**CERTIFICATE OF APPROPRIATENESS**

**Property:** 1330 Cortlandt Street, lot 22, block 168, Houston Heights Subdivision. The property includes an altered historic 4,301 square foot, two-story wood frame single-family residence and a detached two-story accessory structure situated on a 9,900 square foot (75' x 132') interior lot.

**Proposal:** Alteration – *Revision*: The applicant was granted a COA in on December 12, 2013 to construct a two story addition to the rear of a two story contributing residence. At the April 23, 2015 HAHC meeting, was granted a COA to revise their earlier proposal by replacing the non-original round front porch columns with matching new material. The applicant now proposes the following revisions to this COA.

WEST SIDE ELEVATION

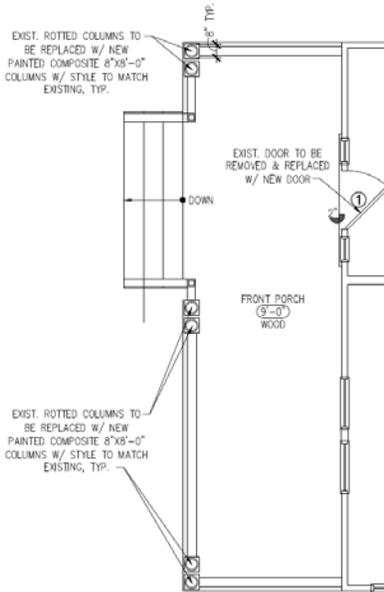
- Replace the approved six pairs of 8" diameter round columns with six 10" square columns.
- Install 19 solar panels on the south facing slope of the roof of the approved rear addition and the detached rear accessory structure.

The applicant now proposes to use 10" square columns instead of pairs of round columns.

1330 Cortlandt – Question need for square column replacement. No evidence that round columns were not original design. Recommend the applicant review offered 12 inch fiberglass round columns (Tuscan style) manufactured by Fiberglass Specialties Inc., P.O. Box 1340, Henderson, Tx 75653 (903) 657-6522. Don't have a problem with fiberglass replacements.

**PROPOSED SOLAR PANELS**  
BIRD'S EYE VIEW

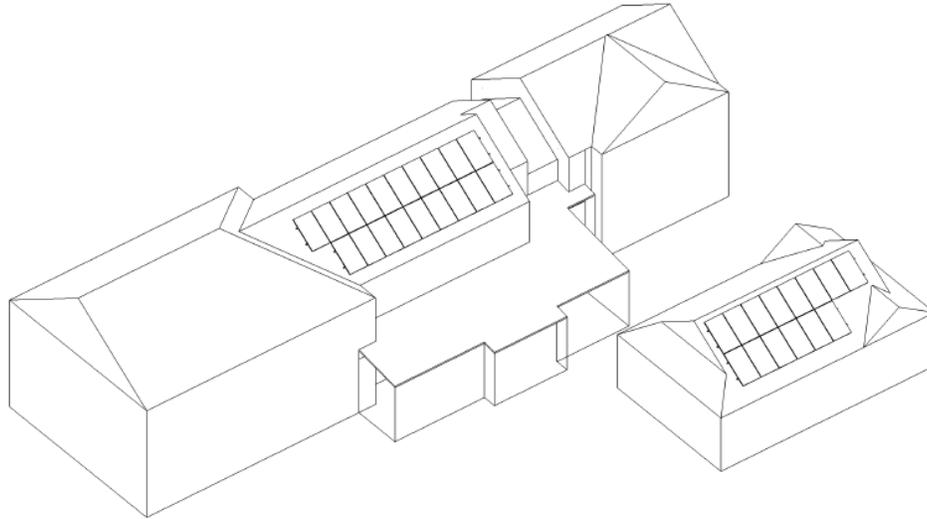
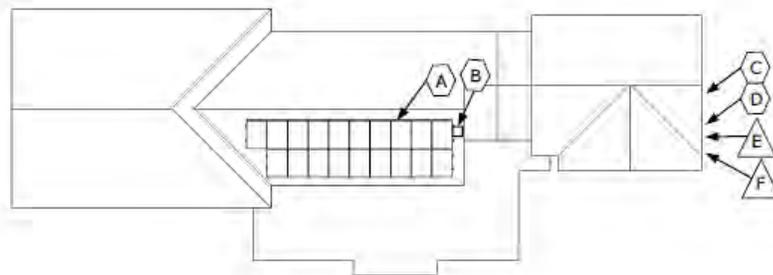
The applicant also proposes to install 19 solar panels on the south side of the roof structure of the approved addition. The panels will feature a profile that is flush with the roofing material. The combined panels measure 11' tall by 32' 6" deep.

1330 Cortlandt solar panels – no objection when solar panels are placed on the non-contributing portion of the structure
